**RE: REV2022/0004 16 Bangaroo Street North Balgowlah**

On behalf of our clients, we provide a submission objecting to the Application for Review of Determination of the proposed Centre Based Childcare centre at 16 Bangaroo Street North Balgowlah.

Figure 1: Required acoustic barriers as outlined in Acoustic Report by Wilkinson Murray

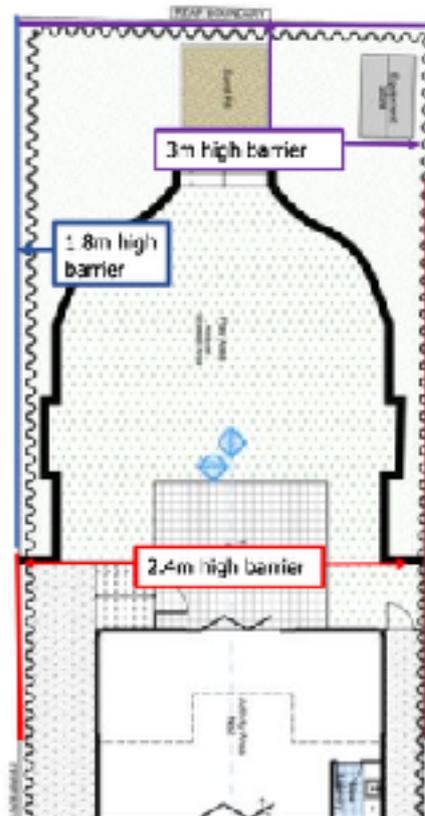
Barriers on the boundary that require a height of more than 1.8m are not considered to be consistent with predominant side boundary fencing of low density residential areas. As shown in Figure 1 below, fences with heights of 2.4 - 3.0m on the boundary as proposed will result in significant adverse visual amenity impacts for neighbours. Creating high boundary walls is not an acceptable response to the visual characteristics of the site or qualities of the surrounding neighbourhood and demonstrates the unsuitability of a site with low background noise levels to a childcare centre.

The materials proposed for the walls have not been nominated and given the acoustic properties needed, it is likely their solidity and height will exacerbate their adverse visual impact.

In addition, walls up to 3m high will cast additional shadow on neighbouring residential properties. This impact has not been identified and diagrams demonstrating the extent of that impact should be submitted to allow the impacts to be properly assessed.
